TOWN OF MILFORD, NH  
OFFICE OF COMMUNITY DEVELOPMENT

## **STAFF MEMO**

**Date:** August 23, 2018  
**To:** Town of Milford Planning Board  
**From:** Lincoln Daley, Community Development Director  
**Subject:** **Hitchiner Manufacturing, Inc., 594 Elm Street, Tax Map 13, Lot 6 and 97 Old Wilton Road, Tax Map 14, Lot 6.** Public Hearing for an amendment to the major site plan approved on May 22, 2018, for the construction of an 85,000 square foot industrial manufacturing building and minor parking improvements to increase the total impervious area for a cooling tower concrete pad and associated drainage improvements within the Industrial zoning district.

FIELD BOOK: 1219	DRAWING NAME: 1109-WL_F021	1109-MM	9 OF 21
DRAWING LOCATION: R:\1109\PROJ\1109-2018.WL		File Number	Sheet

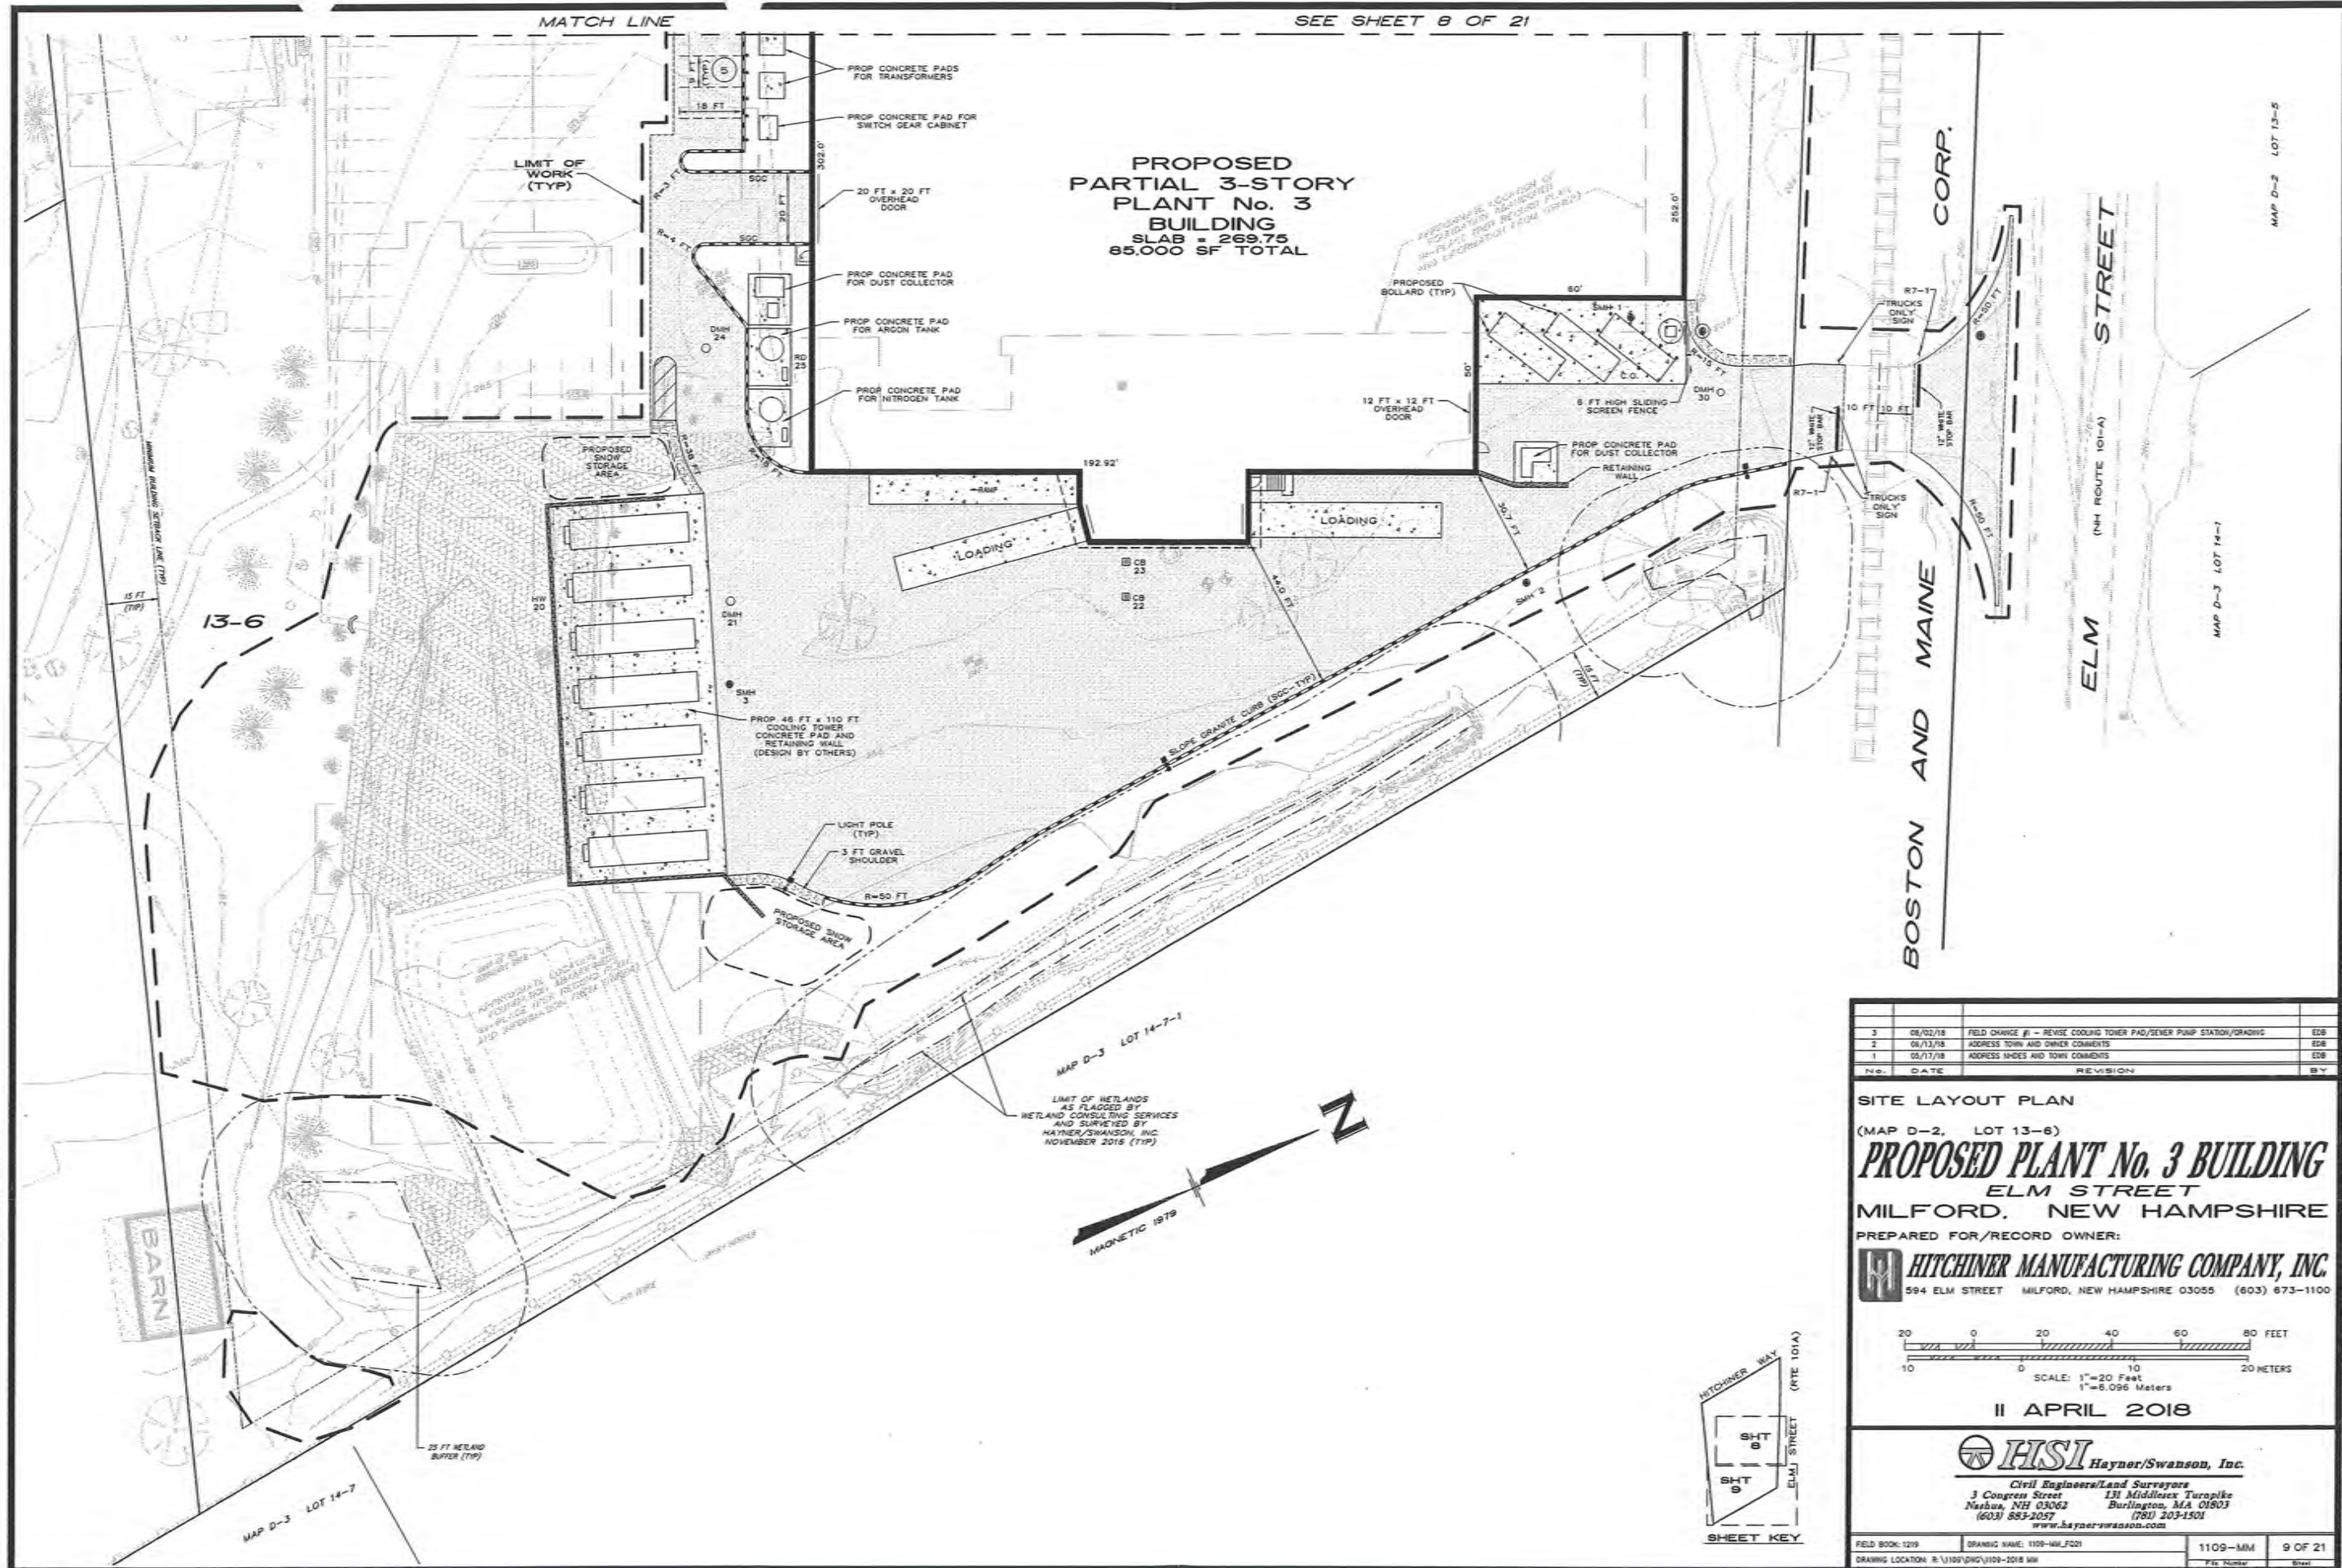
4. Sheet 9. Please revise the plan to include the engineering and construction details for the cooling town concrete pad and retaining wall.
5. Sheet 9. What is the distance/height from the top to the retaining wall to the grade of the riprap and retaining pond? Will a fence need to be installed for increased safety?

6. Sheet 9. Given the proximity of the 7 coolant towers the wetlands, detention pond, and drainage system, please explain what preventative measure/safeguards will be in place should there be spill?

7. Sheet 9. Please explain the reason for locating a snow storage area within the riprap area of the drainage system.
8. Sheet 20. Please confirm if the trees located within the riprap areas will remain (approx. 8 trees). If they are removed, please revise the landscape to show the locations of the replacement/relocated trees.
